LEVEE STABILITY

Three Rivers Levee Improvement Authority

Levee Repairs Project Phases 1, 2 and 4

4-19-2007

TYPICAL FAILURE SURFACE
NTS

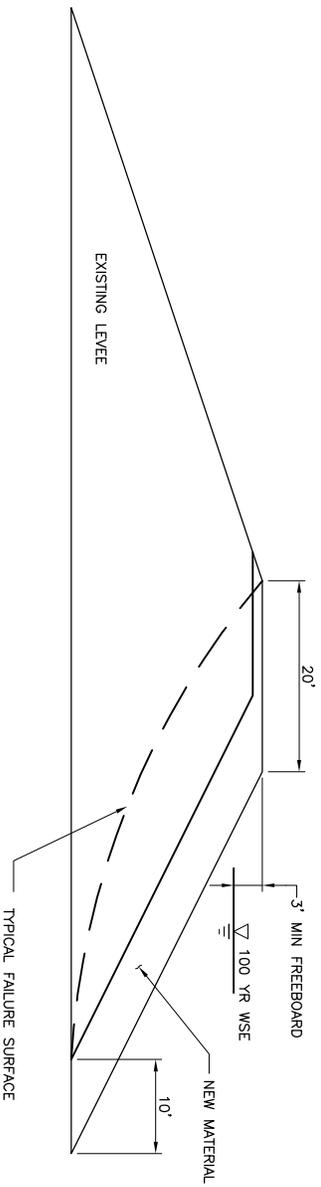
In the vast majority of the cases the new fill was placed in a narrow layer (2 to 3 feet wide) on the waterside of the levee and/or on the crown of the levee (above the 100-year water surface elevation). In these cases, neither the strength nor permeability of the placed material is critical to the overall performance of the levee embankment. This is illustrated in the attached Figure 1 which shows the relationship of the placed fill to a typical critical failure surface and the 100-year water surface elevation.
